**SIB 52 19 19**

**SECOND ROW 60/40 PASSENGERS SIDE SEAT INTERMITTENTLY WON'T LATCH**

This Service Information Bulletin (Revision 2) replaces SI B52 19 19 **dated August 2019**.

GRUSB5219-12

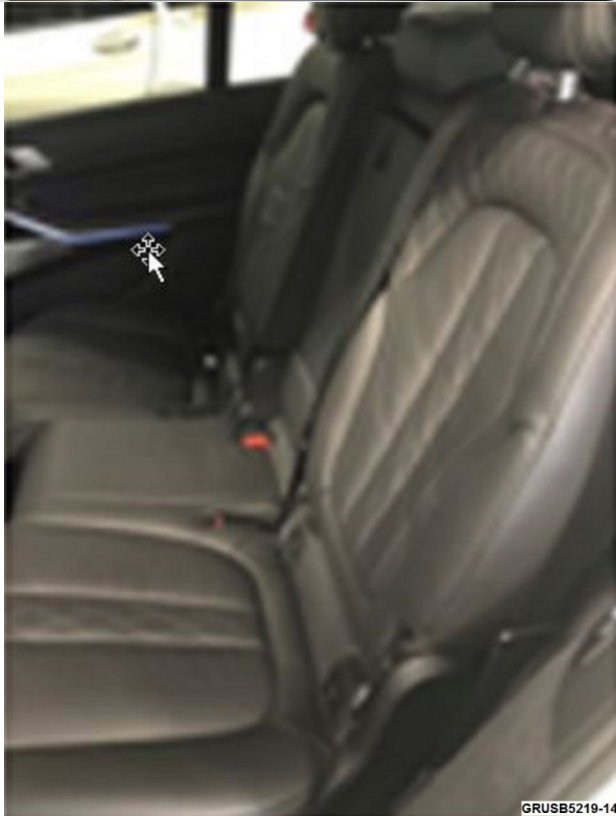
5. Install 1 flat 2 mm thick washer under rear of inner rail of the 40% structure.

Washer is installed between the floor of vehicle and the rear of the inner seat rail.

Note: Only install the 1 washer at the specified location 2 (circled).

- Locations 5 thru 10 pertain to the 60% 2<sup>nd</sup> row seat which is not affected by this repair.

6. Tighten all fasteners to 42 Nm following the torque sequences #1 thru 4.
